REGIONAL REVIEW NOTICE

ARC REVIEW CODE: R1207261

Name of Proposal: DeKalb Farmers Market

SUBJECT: **TD Review of DRI # 2273**

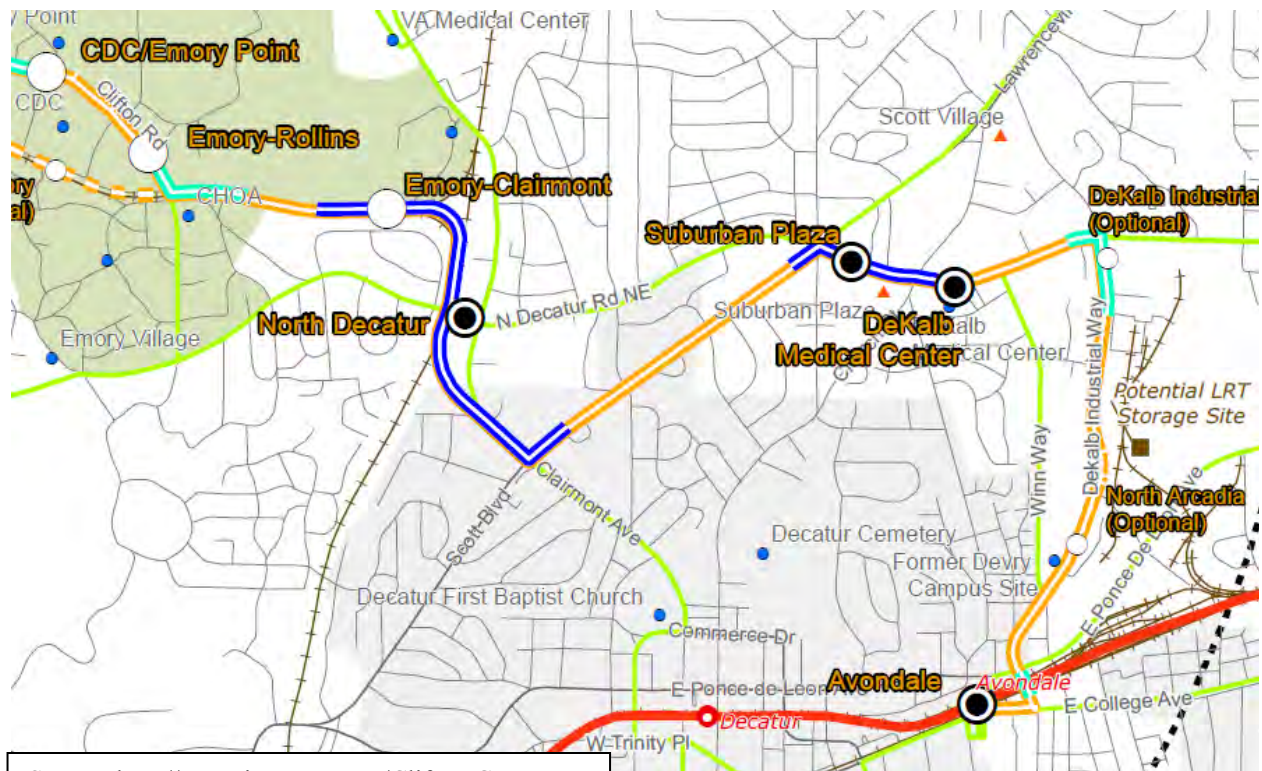
The consultant’s analysis identified four intersections as operating below the LOS D standard for the 2023 (Phase 4) conditions. The following list identifies the intersections and the recommended improvements.

- East Ponce De Leon Ave & N Arcadia Ave/Sams Crossing
 - Recommend dual left turns for westbound approach at the intersection.
 - Optimize signal timing at the intersection.
- East College Drive & N Arcadia Ave/Sams Crossing
 - Optimize signal timing at the intersection
- East College Drive & Commerce Street as well as East College Drive and S McDonough St
 - The proposed land-use for the DeKalb Farmers Market was updated after the methodology meeting with ARC/GRTA dated on April 30 2012. Based on the updated network site trip distribution, the intersections E College Dr and Commerce St and E College Dr & S McDonough St do not carry “significant” amount of traffic based on the GRTA 7% rule. Based on the updated network site trip distribution, no recommendations were provided to intersection E College Dr and Commerce St and E College Dr & S McDonough St.
